REQUEST

Current Zoning: R-3 (single family residential)
Proposed Zoning: I-1(CD) (light industrial, conditional) and MUDD(CD) (mixed use development, conditional)

Approximately 8.39 acres located at the end of Dixie River Road, east of Steele Creek Road, south of Interstate 485. (Council District 3 - Mayfield)

The petition proposes to allow a mixed-use development on vacant land located in Southwest Charlotte, near Berewick and Charlotte Premium Outlets.

• **Proposed Request Details**

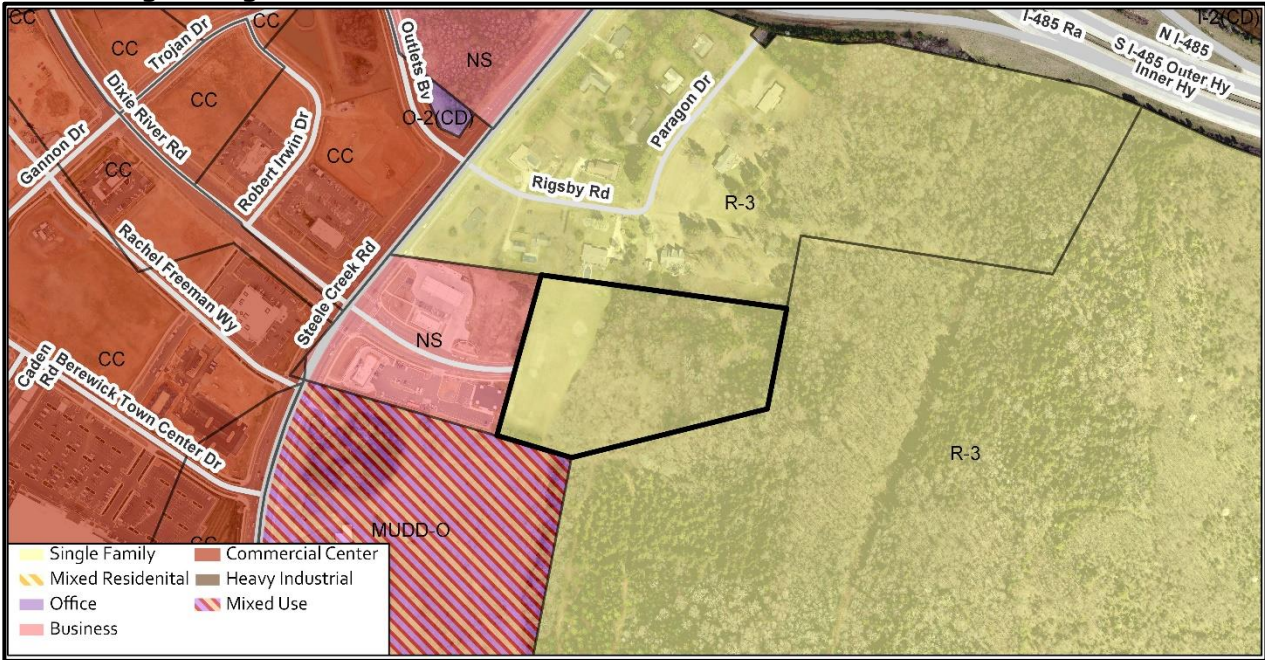
1. ~~Update the site plan conditional note(s) to commit to install 25 mile per hour MUTCD signs on the new public streets.~~ Addressed

2. ~~MUDD areas will be required to provide 15% tree save area onsite. Show tree save area on site map. Tree save area must be 30 feet minimum width. Must contain existing healthy trees.~~ Addressed
